**EWEB Riverfront Master Plan
Summary Public Event #2 - November 10, 2009
Review Design Options**

Attachment B: Verbatim Comments from Small Group Charts

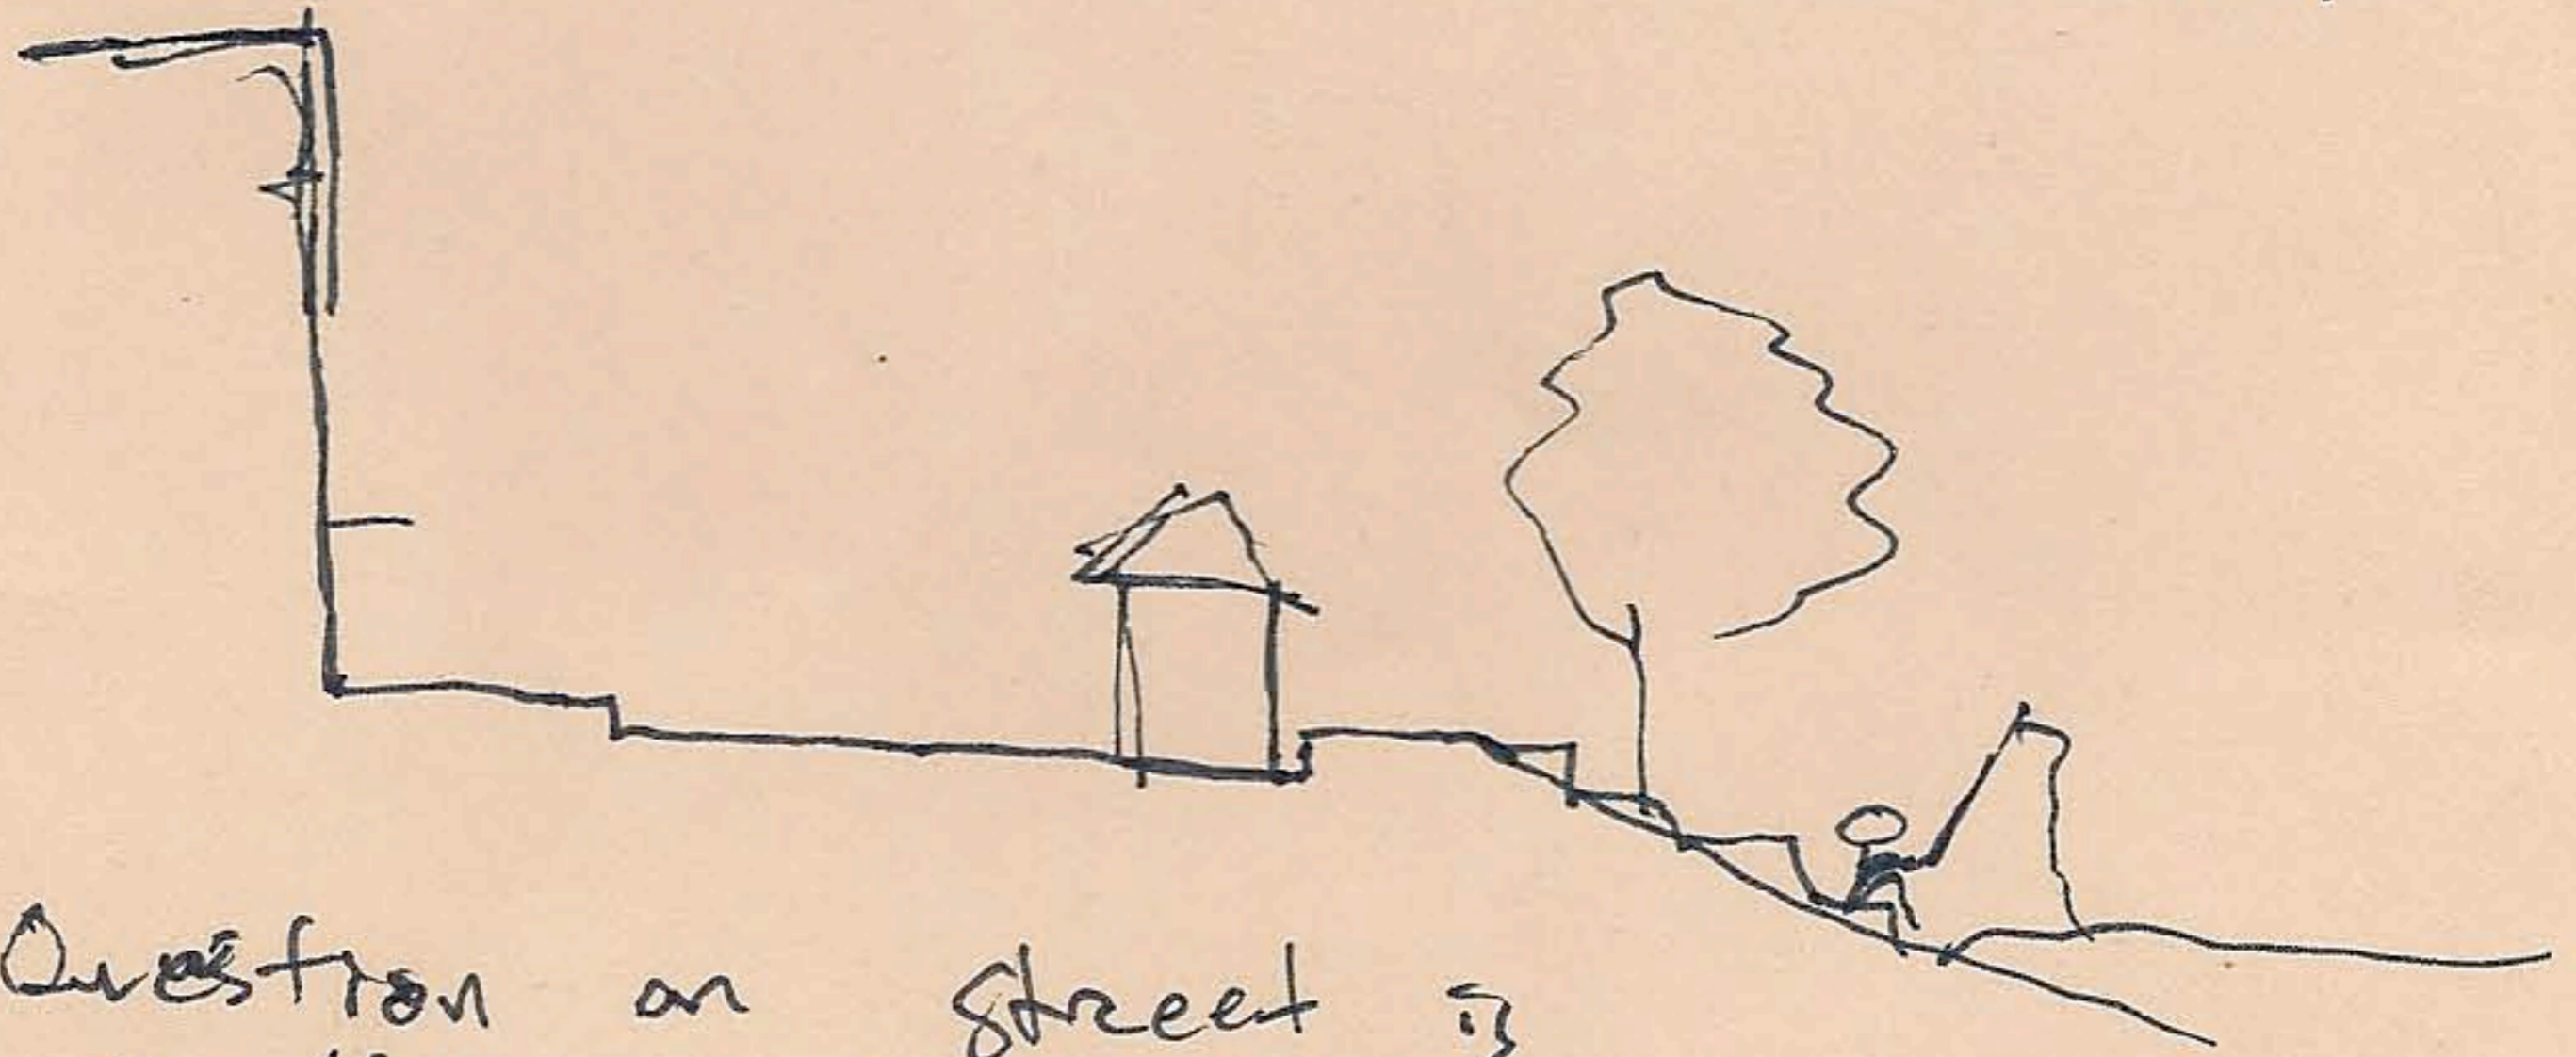
Removing #14 building and adding the green fingers from Option 2 or get rid of #14 and #17 buildings to allow for max open space and possible promenade

COMMENT CARD

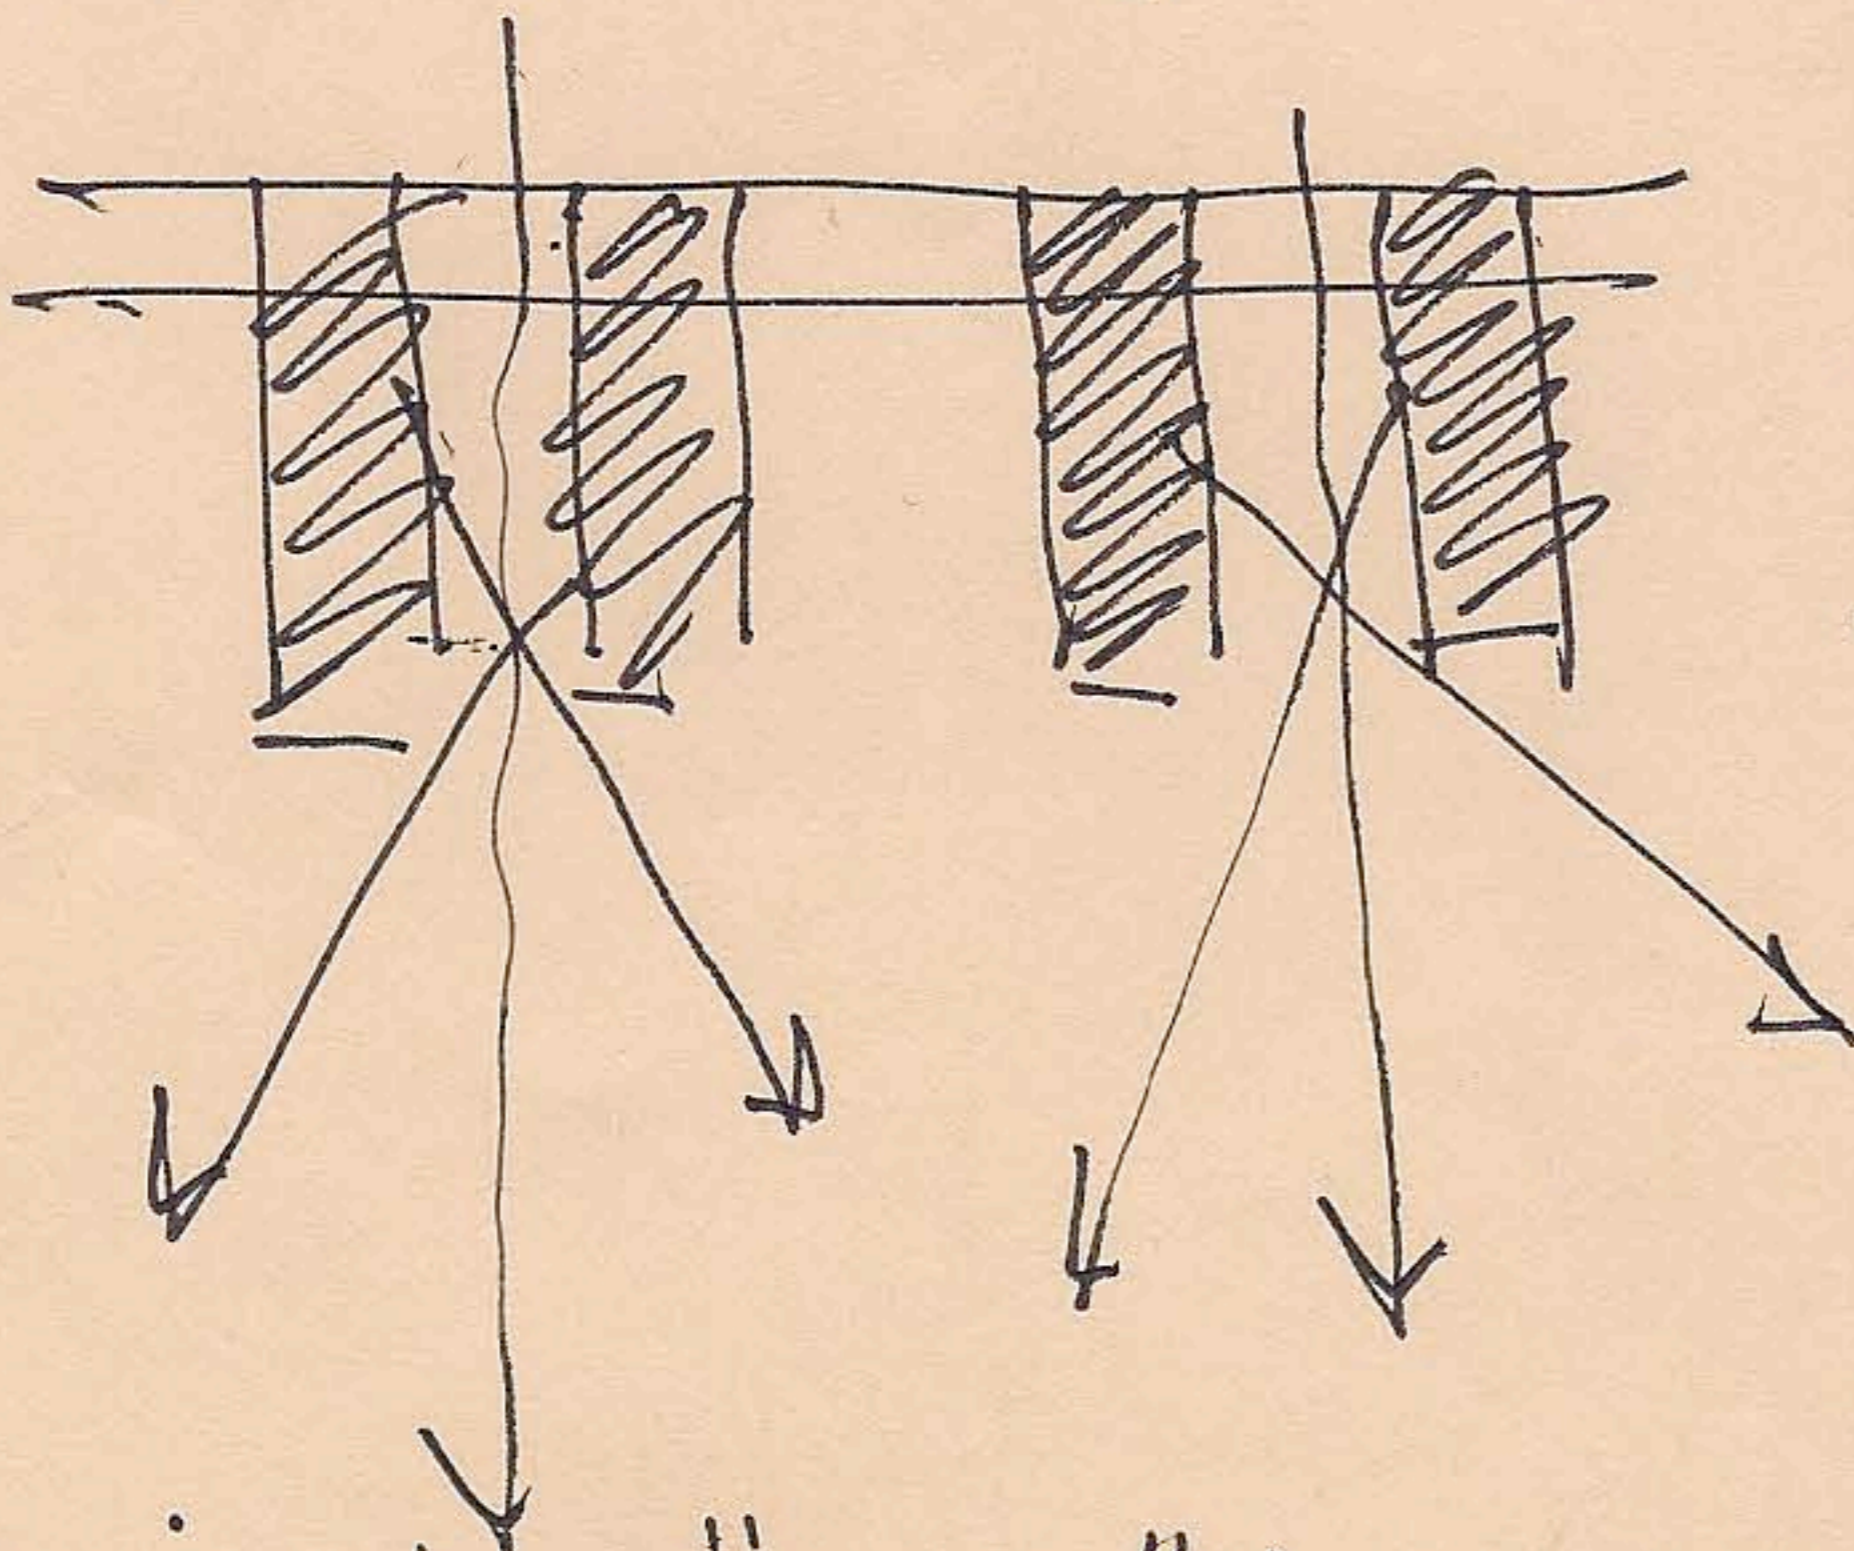
"Framework" of connections providing
access and view corridors to the river
needs to be stronger.

prevent river edge
from being blocked
by first developer
who takes the bank
edge.

What is the "area" in general terms allocated
for development? How is this verified.
open space
built footprint parking etc.
